AMALYN BETHESDA (WMAL BETHESDA)
PRELIMINARY PLAN AMENDMENT NO. 12016029A
SITE PLAN AMENDMENT NO. 82017017B

Nos. 12016029A, 82017017B
Completed: 11-17-2022

MCPB
Item No.
12-01-2022

Figure 5: Proposed Lot Layout and Open Space along Greyswood Road

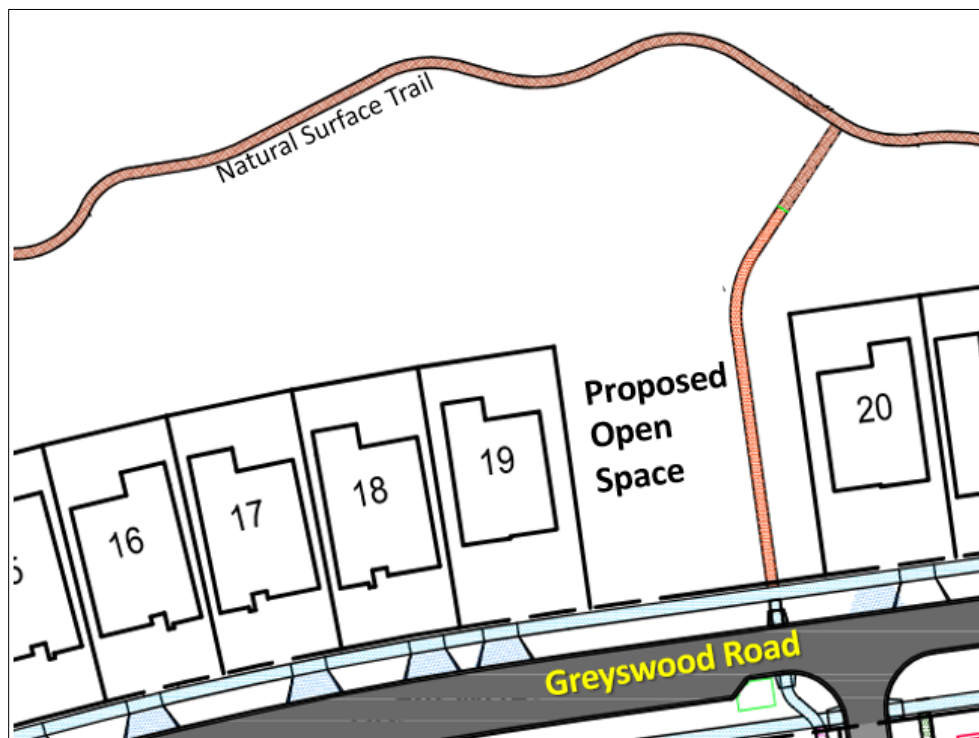
The Applicant proposes to eliminate the crescent which separates Greyswood Road from Private Lane F in the original approvals. Six lots that previously fronted onto Private Lane F would instead front directly onto Greyswood Road, consistent with the lots located to the east and west.

This modification enables the Applicant to provide a usable open space along Greyswood Road, across the street from the community clubhouse (Figures 5 and 6). The proposed open space provides a lawn, a fire pit, landscaping, and seating areas, and it visually connects the clubhouse with the natural surface trail within the northern forest conservation area. One of the approved paths between Greyswood Road and the natural surface trail shifts west to accommodate the modified lot layout and the other path is eliminated. The stormwater management facility that is currently located within the crescent will be relocated in a structure below the new open space area.

Figure 6: Illustrative Plan of Proposed Open Space along Greyswood Road

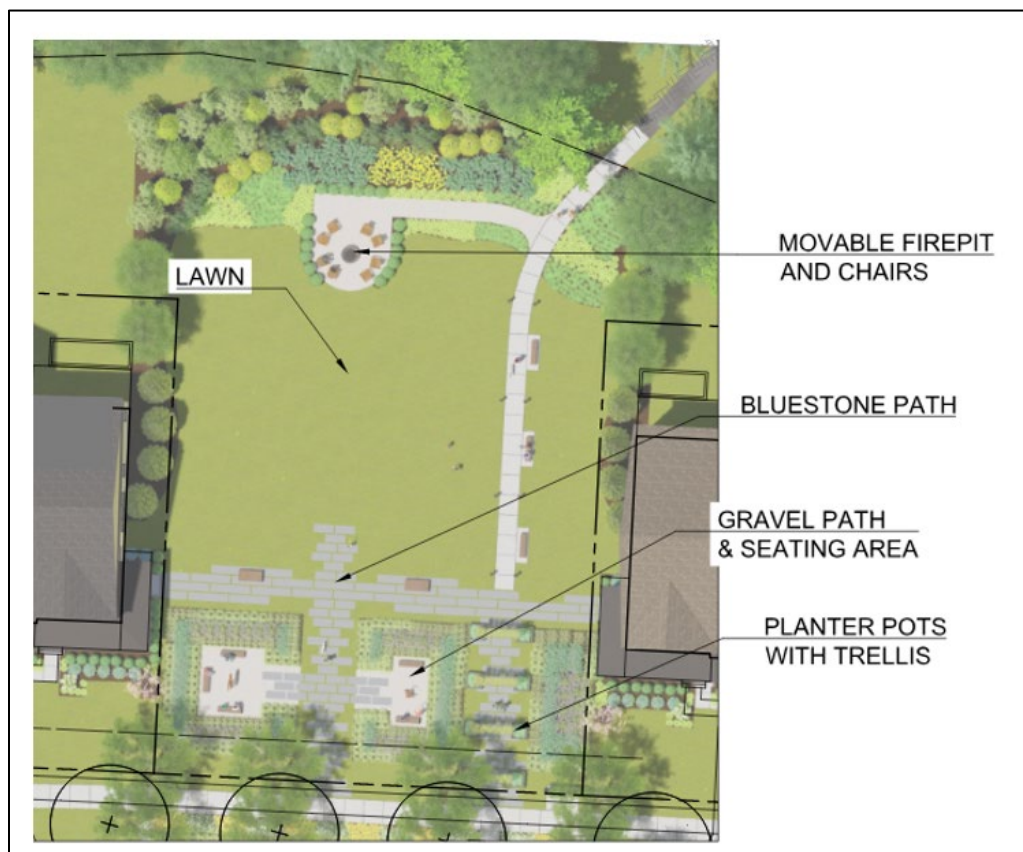
The elimination of the crescent enhances the Project's common open space by providing additional, usable open space for the community. The crescent included storm water management and landscaping but did not provide any usable space. The proposed open space includes a lawn, landscaping, seating and a fire pit in addition to a prominent connection between the clubhouse and the natural surface trail along the northern forest conservation easement. The Amendment provides additional safe, well-integrated amenity features for the community.

Figure 7: Proposed Phasing Plan

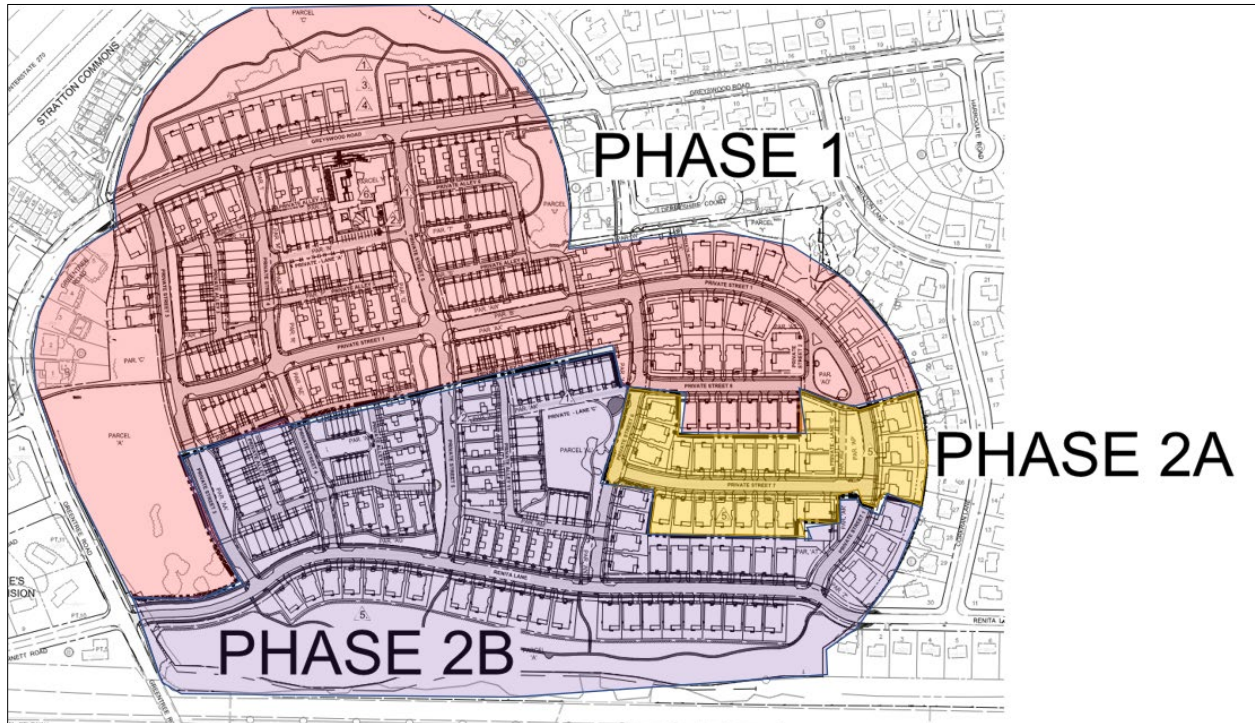
The Site Plan currently shows Phase 2 as a single phase. In order that the development of portions of Phase 2 may be advanced, the Applicant proposes adding a new phase line and splitting Phase 2 into Phases 2A and 2B (Figure 7). This requested revision relates only to timing and does not reflect any substantive change to the approved plans.

Figure 8: Approved Clubhouse Architecture

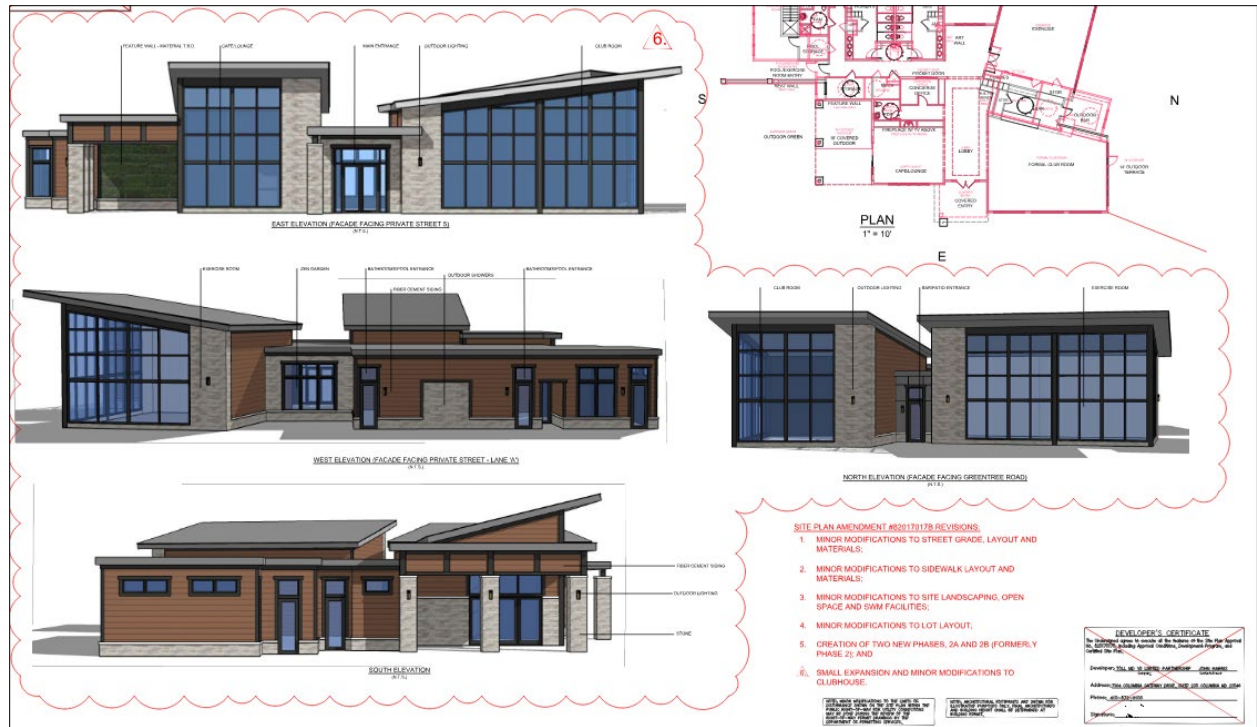
A minor increase of less than 700 square feet is proposed for the clubhouse to accommodate the pool equipment on the main floor. Currently, the pool equipment storage is proposed for the lower level of the clubhouse. However, the Applicant determined that this location presented an operational challenge, given that pool equipment weighing several hundred pounds would need to be moved from the cellar space to the outside twice a year. Minor modifications are also proposed to the clubhouse architecture (Figures 8 and 9), clubhouse amenities, and the building footprint.
